BAR Meeting
April 2, 2014

ISSUE: Partial Demolition/Capsulation and Addition

LOCATION: 314 Prince Street

BAR2014-0063 & 0064

SOUTH ELEVATION
3/16/11-0"

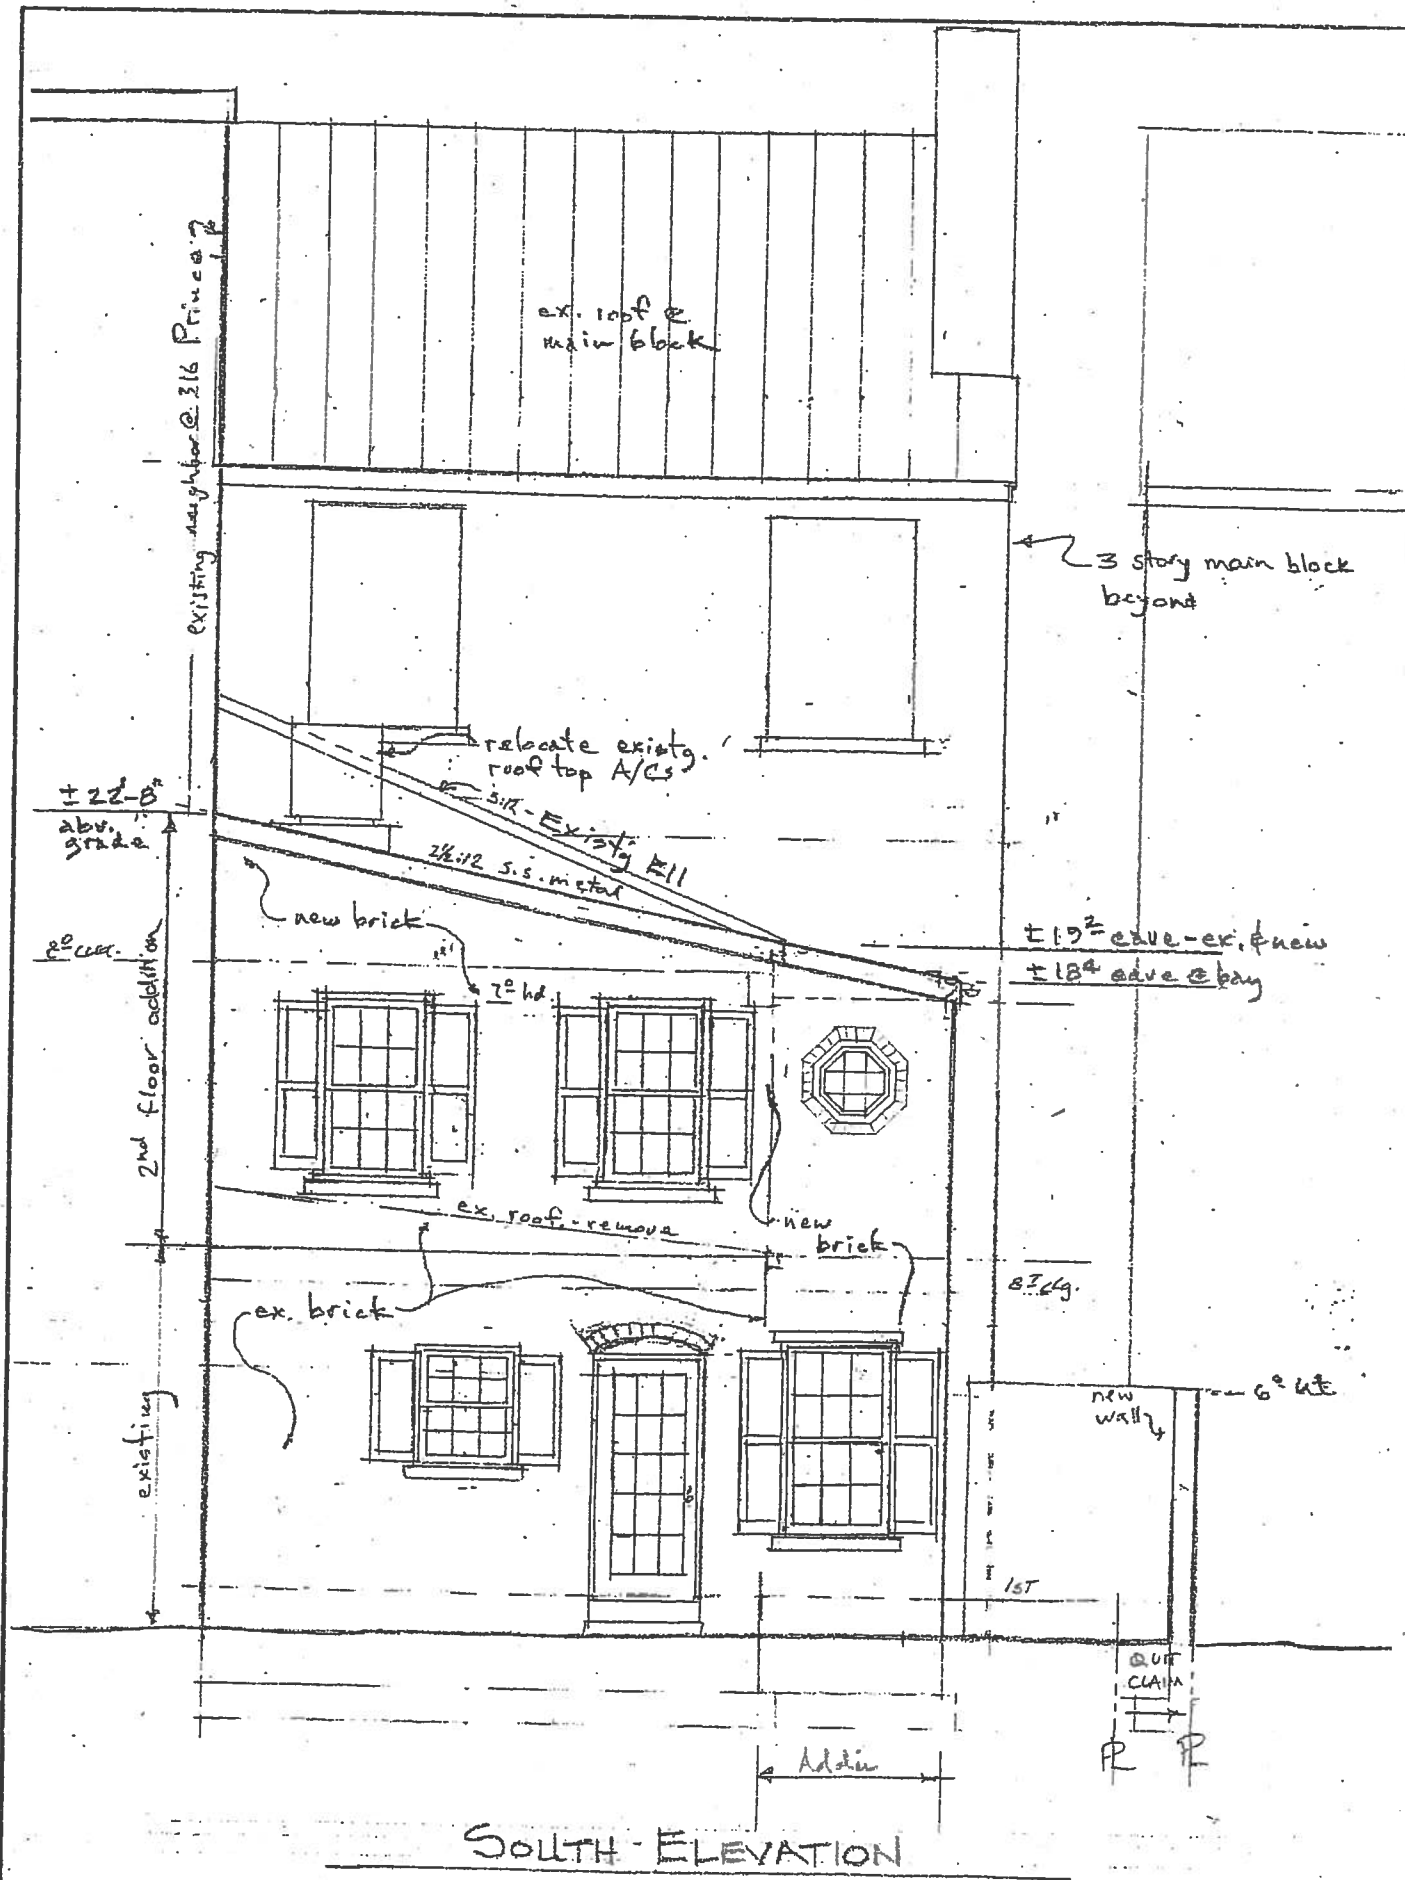
3. The applicant shall work with staff for final design details of the south elevation, pending Code Administration's determination regarding new openings in this location.

The architect has noted that the south elevation is on the property line, abutting an easement for the subject property. The architect will be pursuing a building code modification to allow for new window openings on the south elevation as there is an easement for the subject property's use of that area. Should the applicant not be able to receive a code modification, then the proposed new window openings will not be permitted.
